UNITED STATES PATENT AND TRADEMARK OFFICE

Office Action Summary

10/781,088

DETAILED ACTION

**FIG. 6**

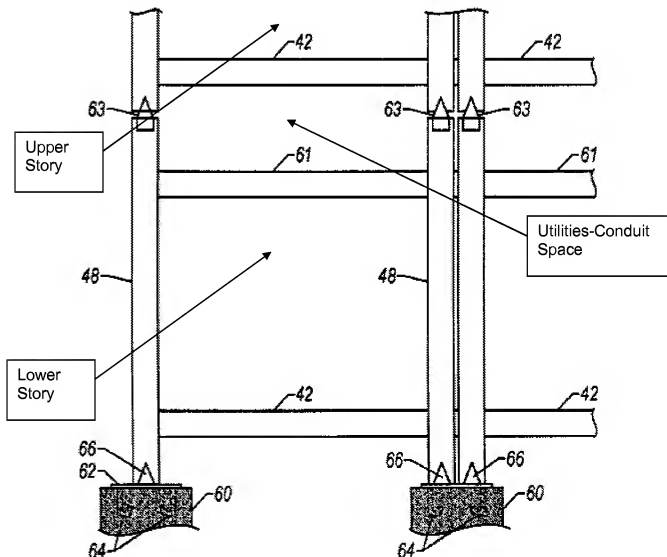
Claims 1 and 3-7 are rejected under 35 U.S.C. 103(a) as being unpatentable over Parker et al. (US 6625937) in view of Davis (US 6347487). Regarding claims 1 and 6, Parker illustrates in Figure 6 a plural-story building structure (Figure 6 of Parker) comprising a pair of vertically spaced stories including a lower story and a higher story (See Figure below), with each possessing a normal full plate-height internal volume, and with the lower story additionally being characterized by an internal volume which is defined, at least in part, by an unimpeded full plate-height, wherein a full plate-height story is defined as having a height extending from a building-story floor elevation (top of 42) to the building-story ceiling elevation (bottom of 61) for any story of the building, and wherein said building-story floor elevations and said build-story ceiling elevation are those elevations coincident with beams (42 and 61) in the plural-story building structure, and a utilities-conduit containment space (See Figure below) in the form of a sub-story disposed independently and directly vertically intermediate said lower and higher

stories, possessing a less than normal full plate-height internal volume, having height which lies wholly above the lower story and wholly below the higher story.

However, Parker does not distinctly disclose the space between the floors housing utilities. It is well known in the art of building construction to house utilities within spaces between floors (such as within the beams separating the floors, drop ceilings, and raised floors). Davis illustrates in Figures 6 and 14 a sub-story (10) being constructed and arranged to contain utilities-conduit structure (95-98) relevant to the supply of utilities services upwardly (see column 9) from said containment space toward said higher story, with related utilities services supply to said utilities-conduit structure extending thereto in a manner avoiding any presence within the mentioned internal volume of said lower story, wherein the height of the sub-story does not diminish the full plate-height internal volume. It would have been obvious to one having ordinary skill in the art at the time of invention to utilize the space small space between the upper and lower stories of Parker as a housing for utilities as in Davis in order to save space and enhance the safety and aesthetics of the structure by limiting the amount of wiring and piping within the living space.

Regarding claim 3, Davis illustrates in Figure 6 and Parker illustrates in Figure 6 the lower stories being ground-level stories.
